Project	IEEE 802.16 Broadband Wireless Access Working Group < http://ieee802.org/16 >
Title	Ranging Primitive Example
Date Submitted	2006-09-12
Source(s)	Peretz Feder - Lucent Technologies [mailto: pfeder@lucent.com]
Re:	
Abstract	This contribution is addendum to Appendix F
Purpose	Adoption
Notice	This document has been prepared to assist IEEE 802.16. It is offered as a basis for discussion and is not binding on the contributing individual(s) or organization(s). The material in this document is subject to change in form and content after further study. The contributor(s) reserve(s) the right to add, amend or withdraw material contained herein.
Release	The contributor grants a free, irrevocable license to the IEEE to incorporate material contained in this contribution, and any modifications thereof, in the creation of an IEEE Standards publication; to copyright in the IEEE's name any IEEE Standards publication even though it may include portions of this contribution; and at the IEEE's sole discretion to permit others to reproduce in whole or in part the resulting IEEE Standards publication. The contributor also acknowledges and accepts that this contribution may be made public by IE

Figure F9 – The use of Ranging Primitives

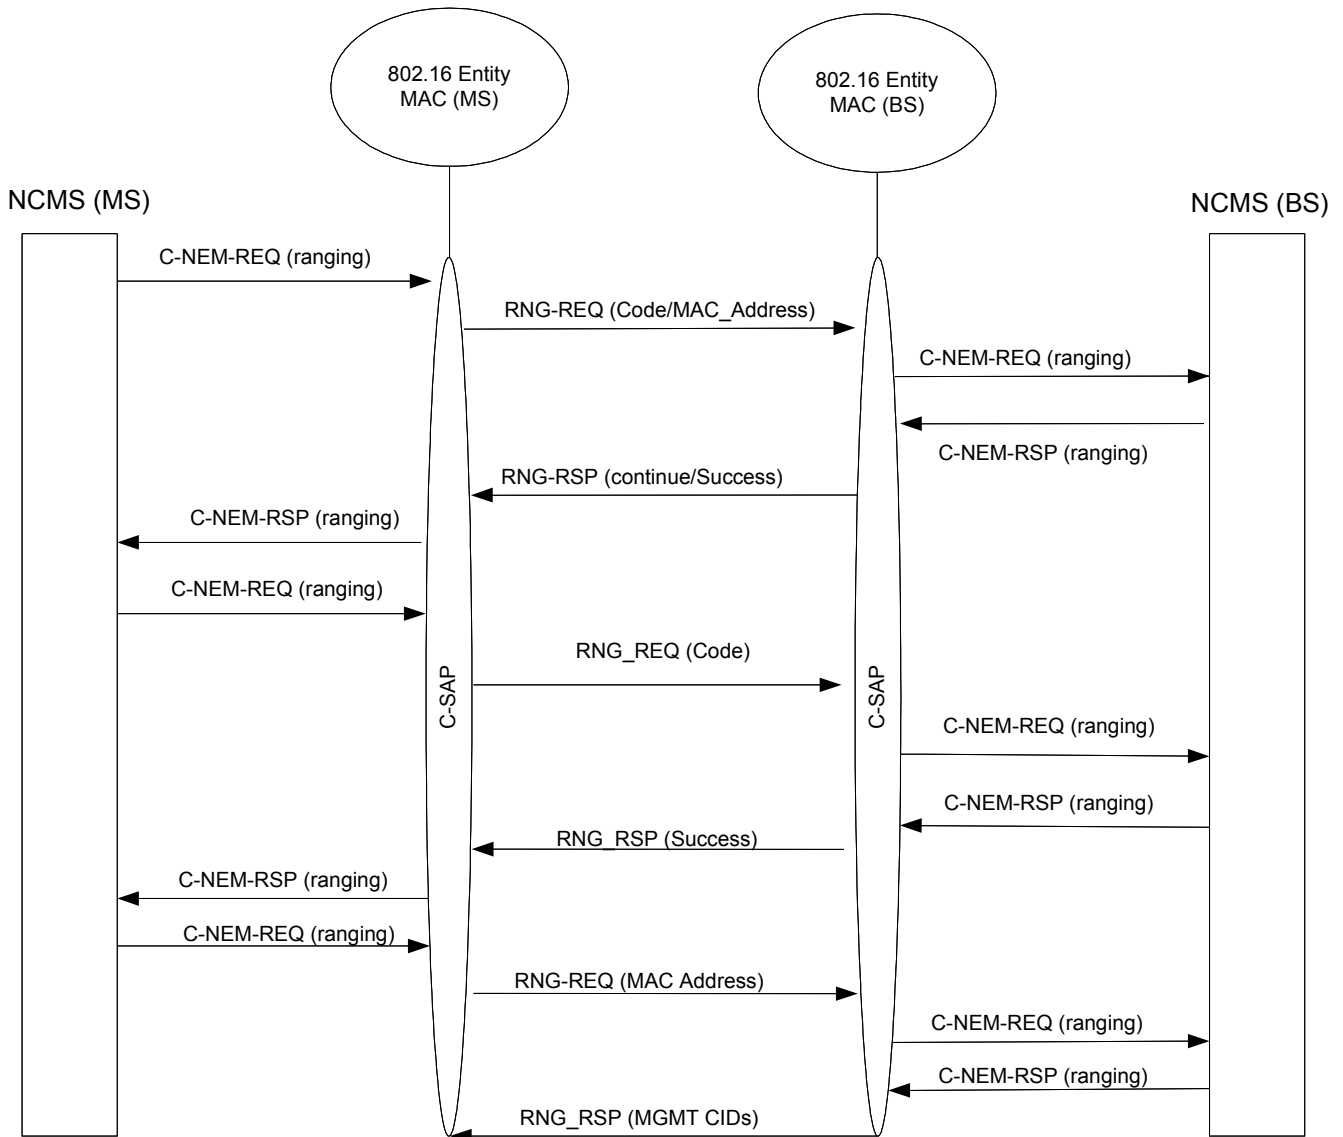
Add Section F.4

Add the following Figure to the Annex F
